## HISTORIC AND DESIGN REVIEW COMMISSION

November 18, 2020

**HDRC CASE NO:** 2020-435  
**COMMON NAME:** 1111 & 1115 N Palmetto  
**LEGAL DESCRIPTION:** NCB 1302 BLK 3 LOT E 144.84 FT OF 10  
**ZONING:** R-5, H  
**CITY COUNCIL DIST.:** 2  
**DISTRICT:** Dignowity Hill Historic District  
**APPLICANT:** James Benfield/Benfield Real Estate  
**OWNER:** James Benfield/Benfield Real Estate  
**TYPE OF WORK:** Construction of two, 2-story residential structures  
**APPLICATION RECEIVED:** September 28, 2020  
**60-DAY REVIEW:** Not applicable due to City Council Emergency Orders  
**CASE MANAGER:** Edward Hall  
**REQUEST:**

The applicant is requesting a Certificate of Appropriateness for approval to construct two, 2-story residential structures on the vacant lot to the immediate north of Alder Street and to the immediate south of an unnamed alley. Within this request the applicant has proposed the following:

1111 N. Palmetto  
Lot: 23, Block: 3, NCB: 1302  
Bella Dignowity Residential Subdivision  
Bexar County, Texas

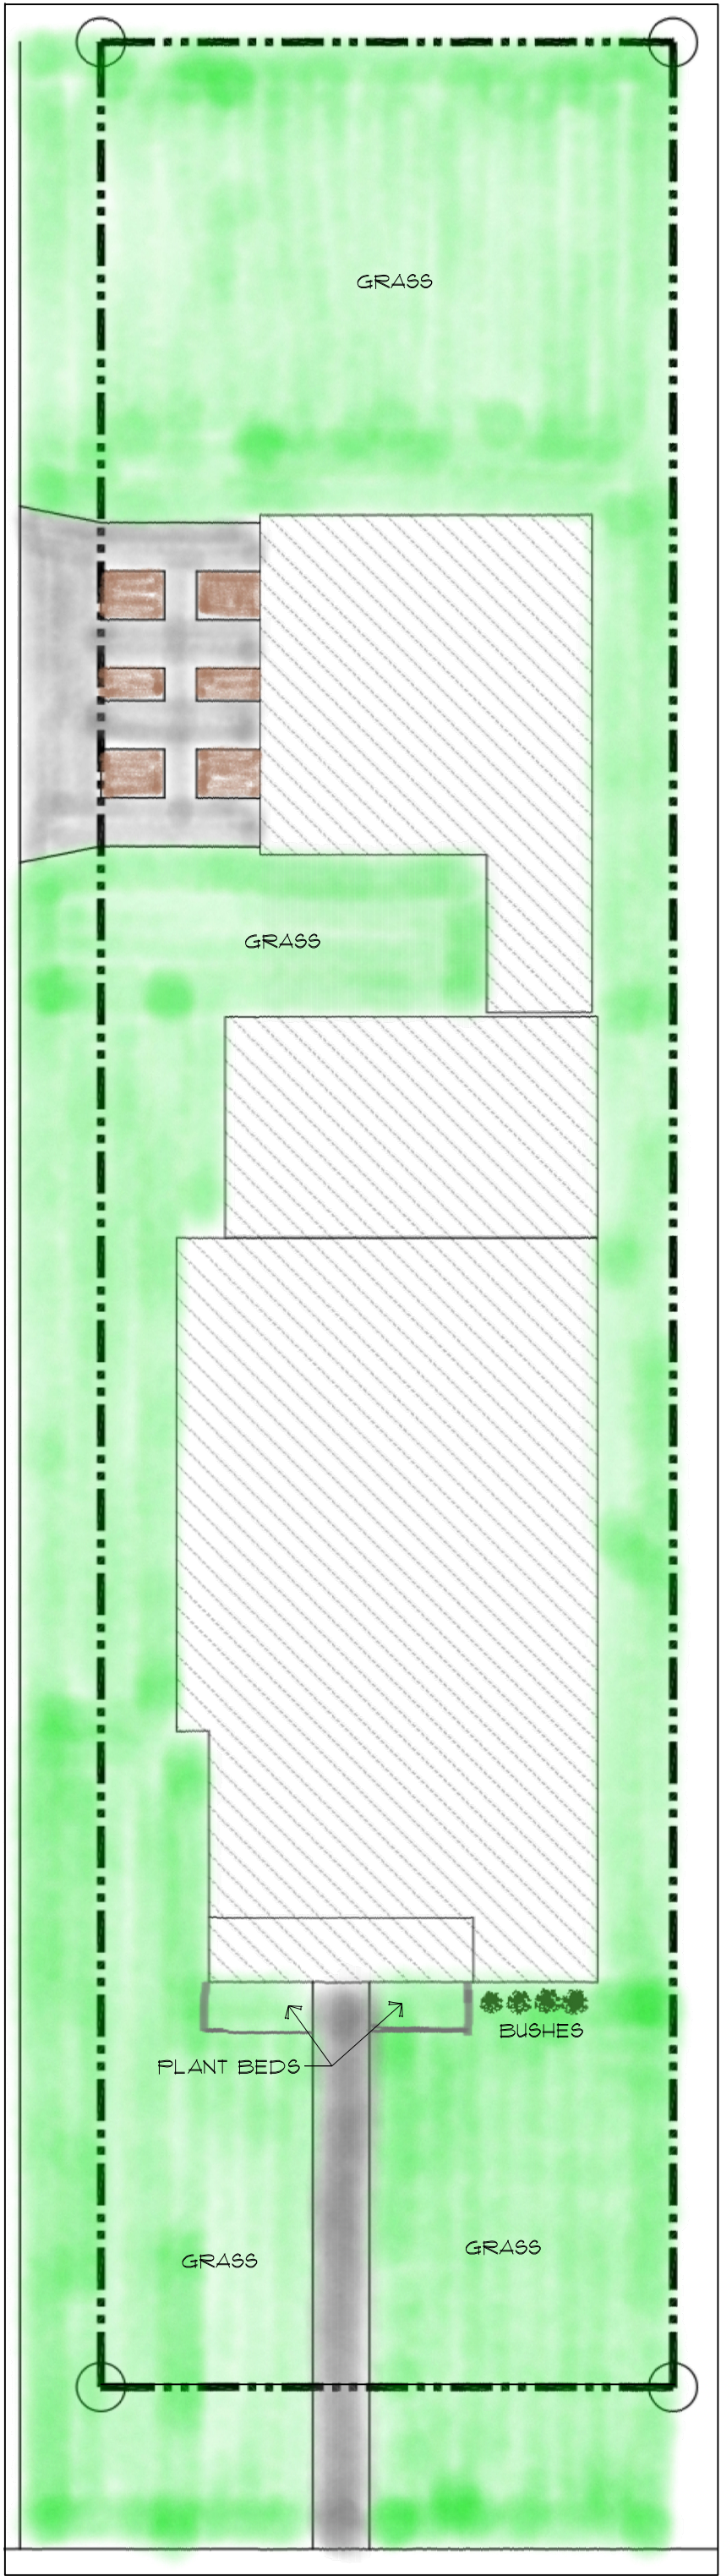
- 1a. **SETBACKS** – The applicant has submitted a setback diagram noting a setback that is greater than all existing, historic setbacks on the block with the exception of one structure, the historic structure at the corner of N Palmetto and Sherman. Generally, staff finds that the proposed setback is appropriate and consistent with the Guidelines by responding to the setbacks of the most immediate historic structures. Staff finds that setbacks should not be so deep as to be dissimilar to those found on the block.

- 1h. **LOT COVERAGE** – Per the submitted site plan, the proposed lot coverage is consistent with the Guidelines.
- 1i. **MATERIALS** – The applicant has proposed materials that include composite siding, asphalt shingle roofs, wood columns and wood trim. The proposed siding should feature an exposure of four inches, a smooth finish, a thickness of ¾” and mitered corners. Columns should be six inches square and feature both capital and base trim as well as chamfered corners. The applicant is responsible for submitted a column detail to staff.

- 1n. SITE ELEMENTS (Driveways) – The applicant has proposed to access the rear carport with a driveway of twenty-one (21) feet in width. This is inconsistent with the Guidelines. Staff finds that the proposed driveway should be separated in width to be consistent with the Guidelines.

- iii. That the applicant install windows that meet staff's standards specifications as noted in findings 1j and 2j.
- iv. That the proposed driveways be separated in width to be consistent with the Guidelines as noted in findings 1n and 2n.

- vii. That the setbacks be adjusted to not be so deep as to be dissimilar from those found historically on the block.

SITE PLAN

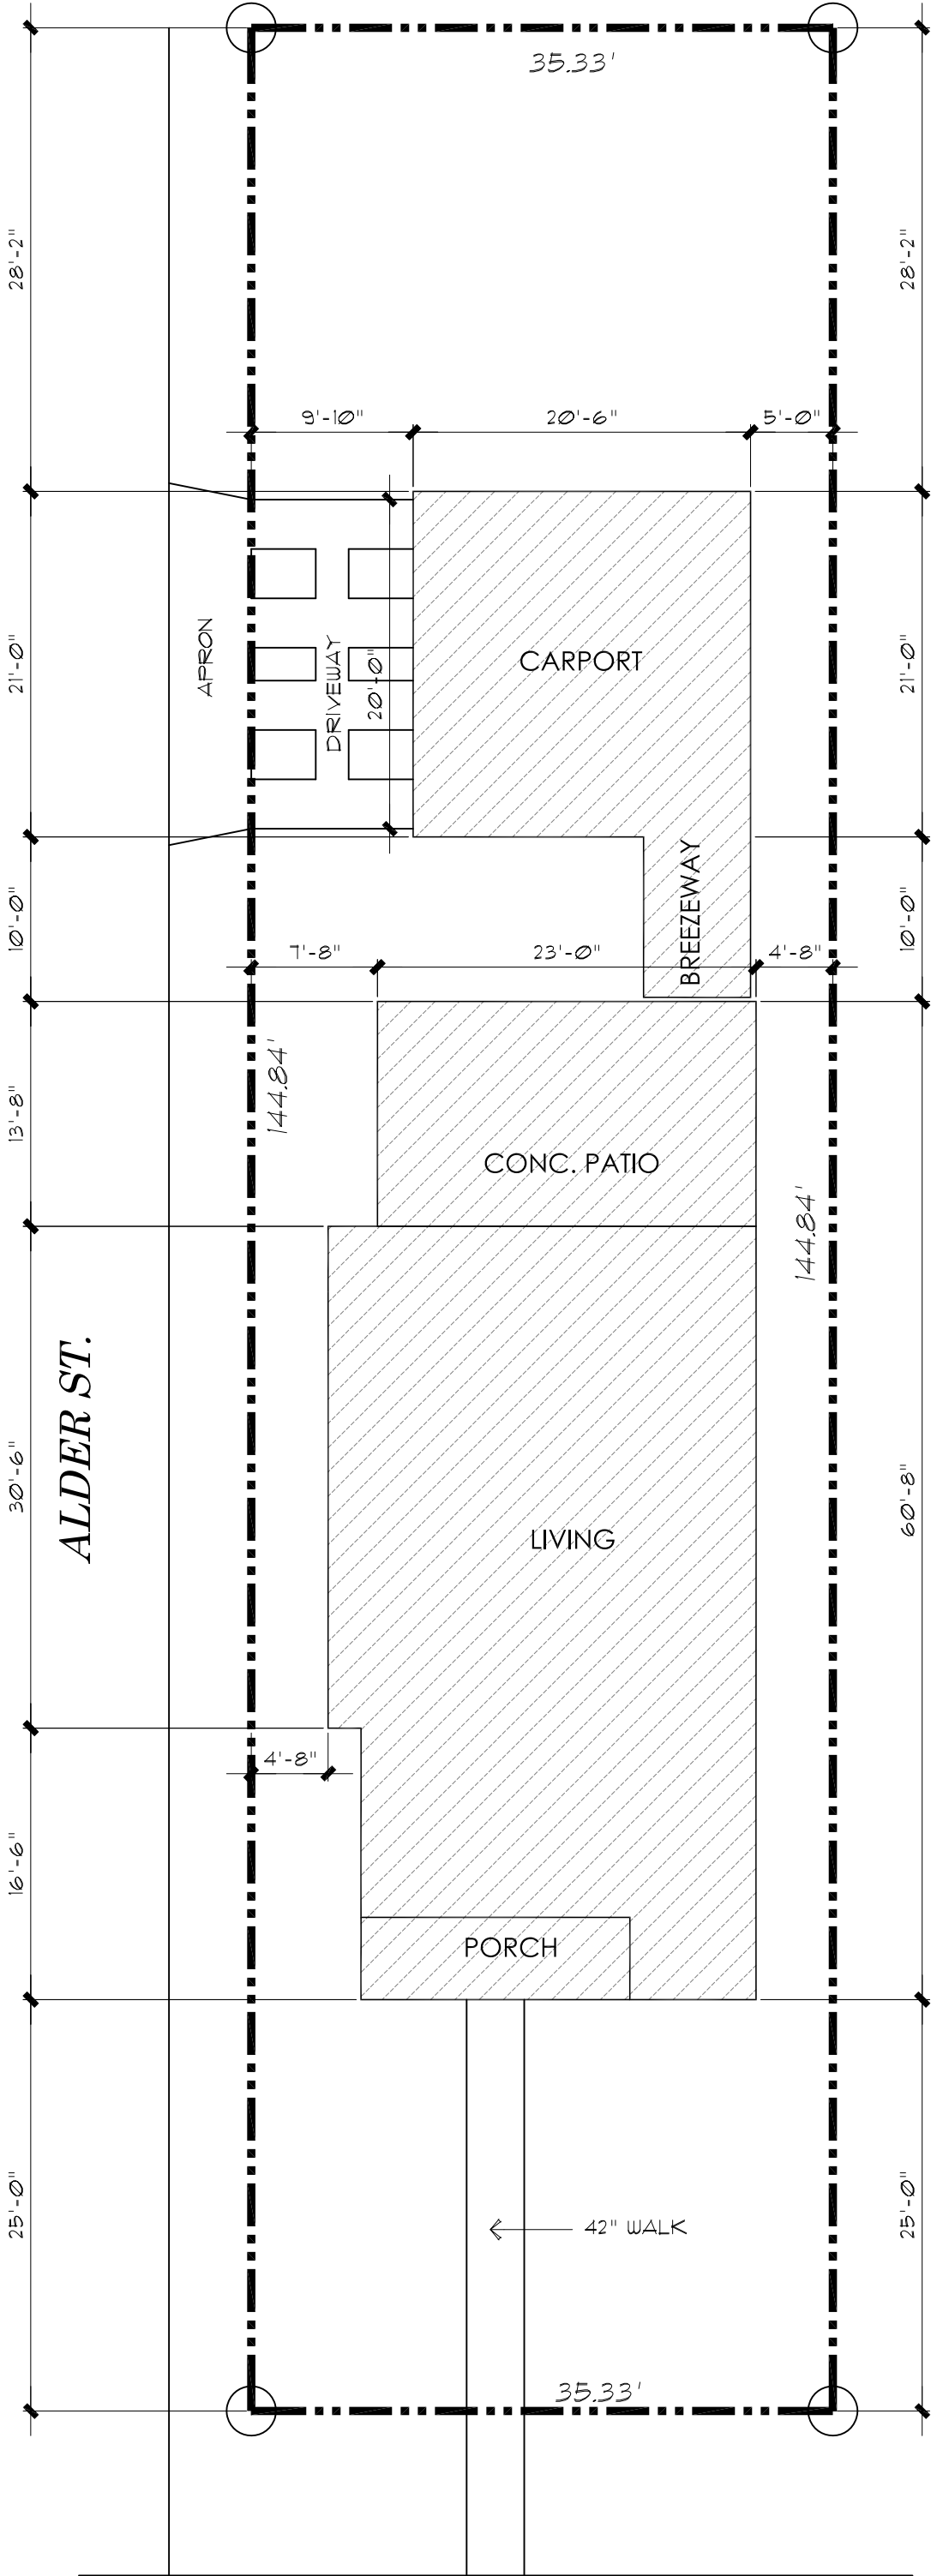
- 1p. SITE ELEMENTS (Landscaping) – The applicant has not provided information regarding landscaping at this time. Staff finds that a detailed landscaping plan should be developed that is consistent with the Guidelines for Site Elements.

- v. That a detailed landscaping plan be submitted for review and approval as noted in findings 1p and 2p.
- vi. That all mechanical equipment be screened from view from the public right of way as noted in findings 1q and 2q.

First Floor Plan SCALE: 1/4"=1'-0"

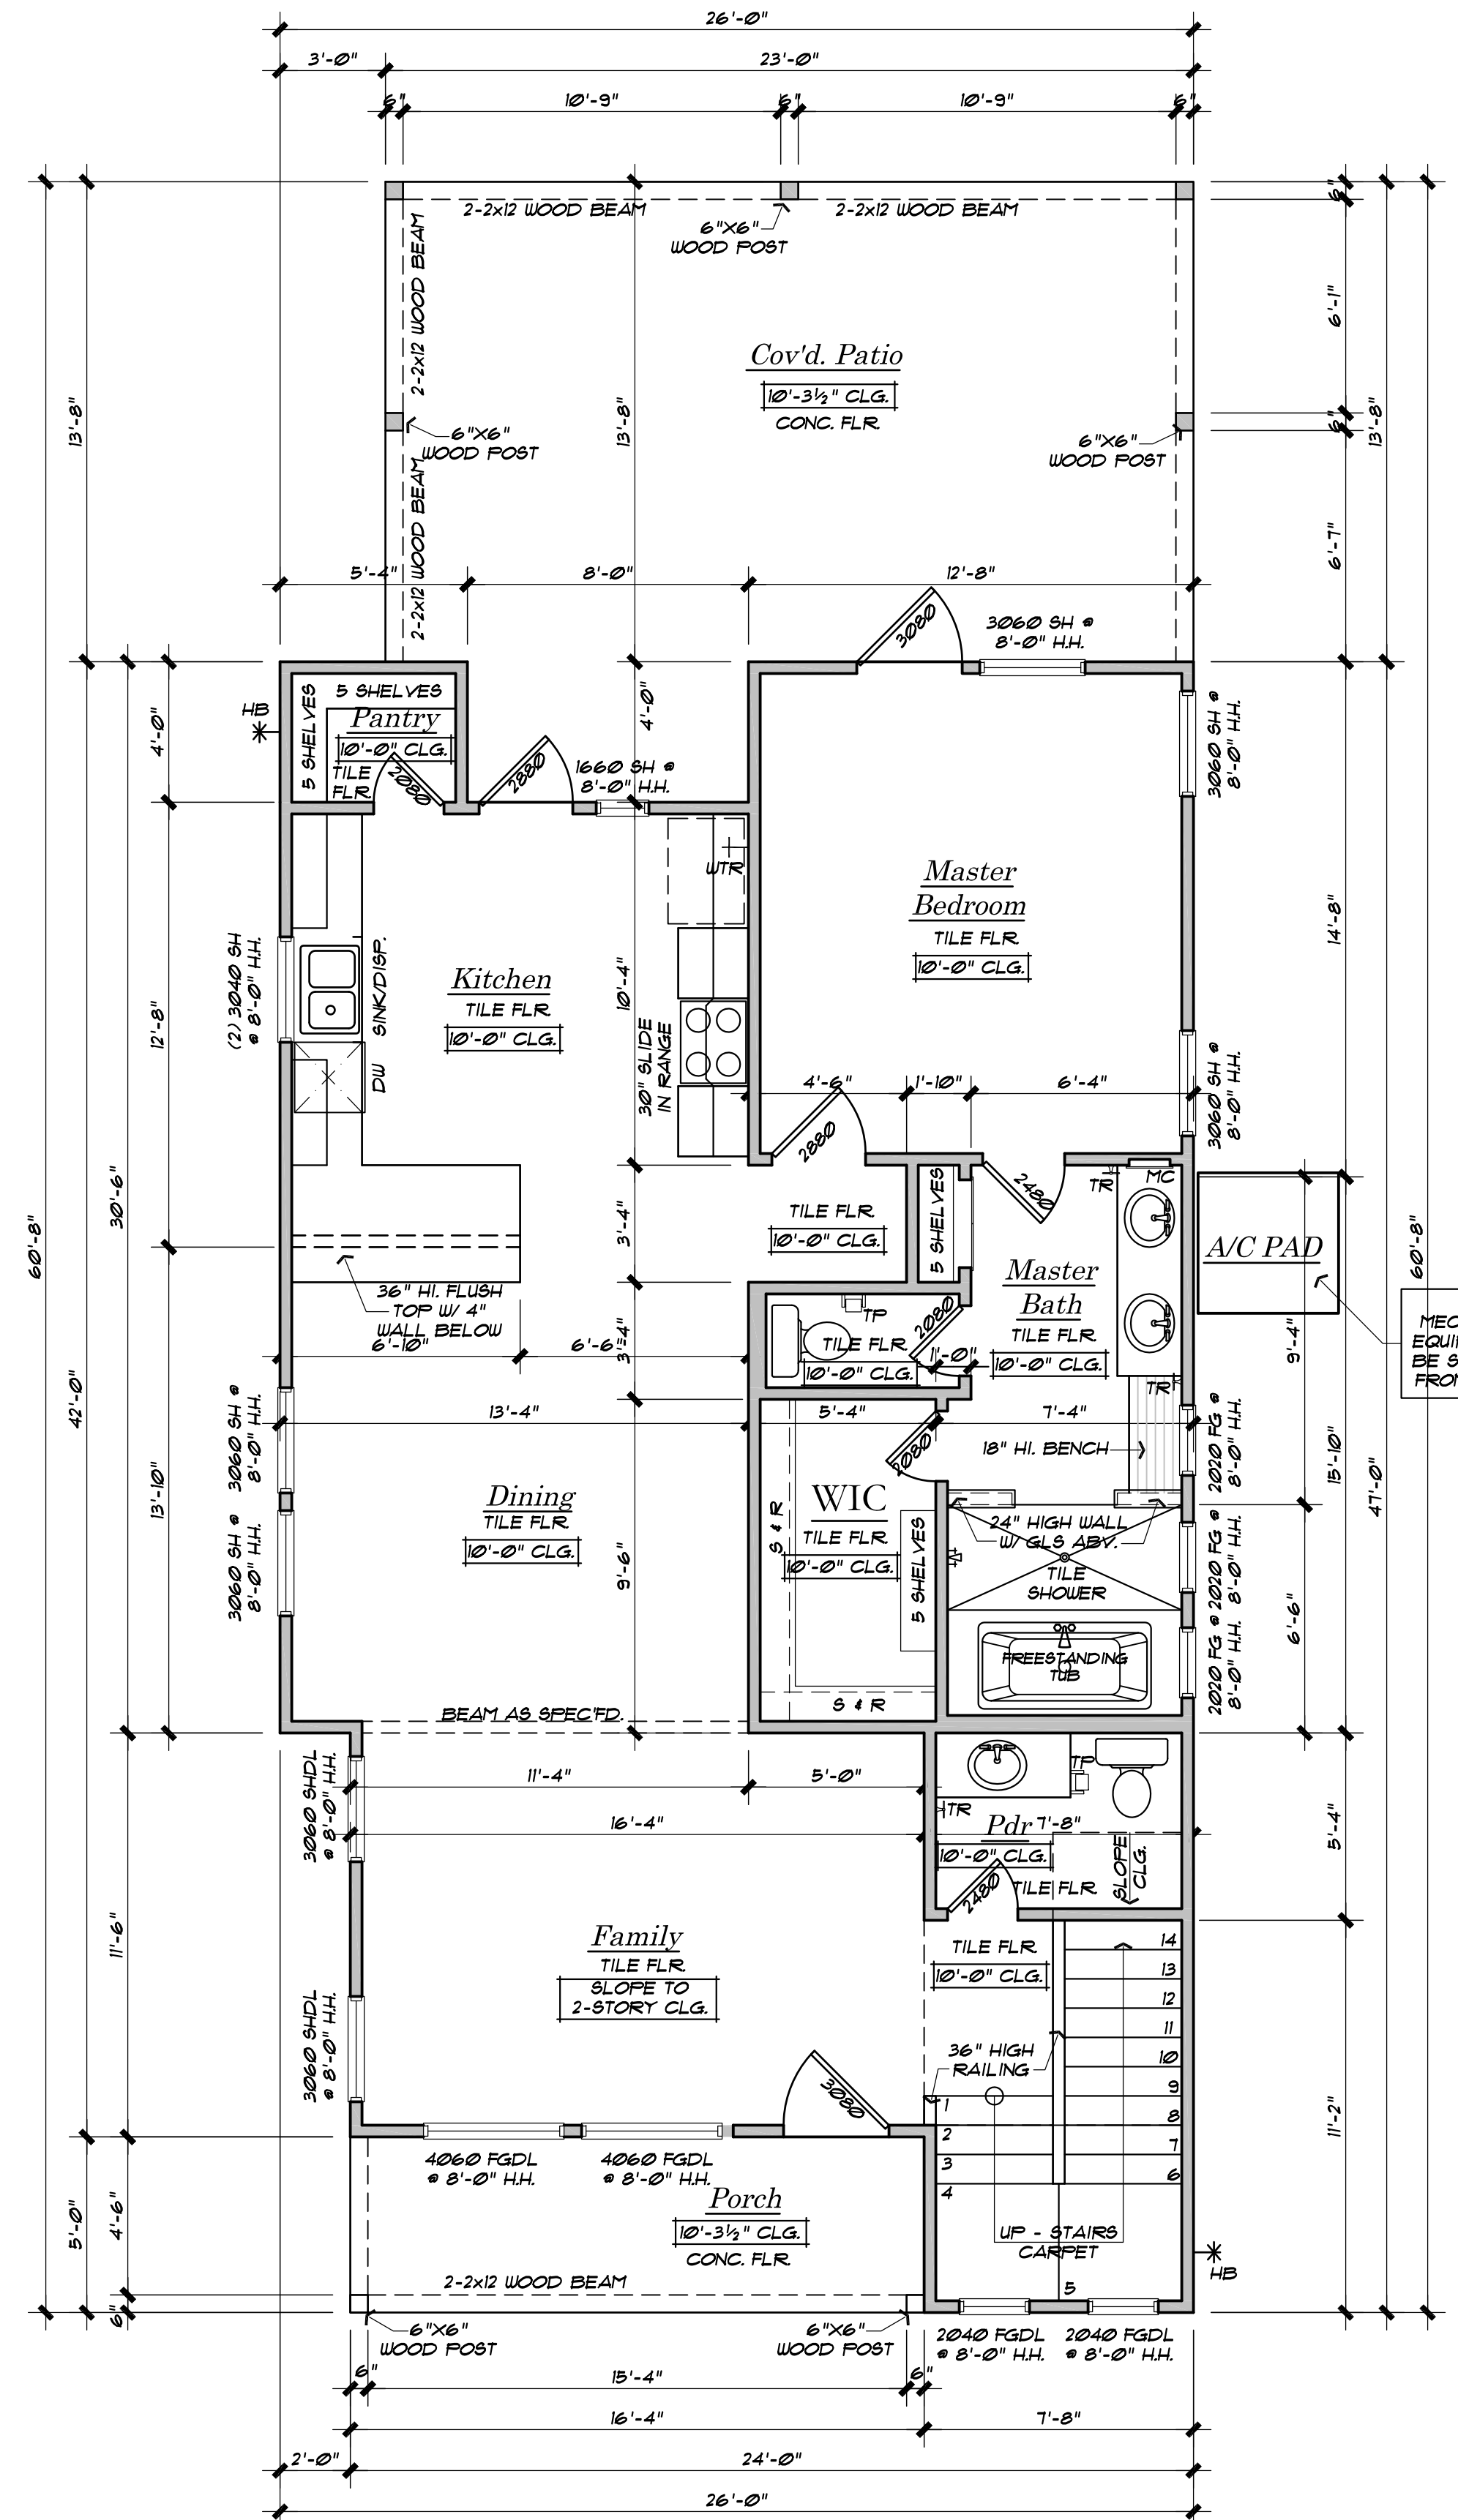
- 1d. **FOUNDATION & FLOOR HEIGHTS** – Per the Guidelines for New Construction 2.A.iii., applicants should align foundation and floor-to-floor heights within one foot of floor-to-floor heights on adjacent historic structures. The applicant has not specified the exact foundation height. The applicant is responsible for complying with the Guidelines regarding foundation heights.

CF: 12 inch foundation height would be appropriate.

- i. That foundation heights that are consistent with the Guidelines be utilized as noted in findings 1d and 2d.
- ii. That all ganged and grouped windows be separated by a mullion of at least six (6) inches in width. Additionally, staff recommends that windows should be added to both the north and south facades near the front of both structures and that non-traditionally sized window openings should be eliminated, such as fixed square windows, as noted in findings 1f and 2f.
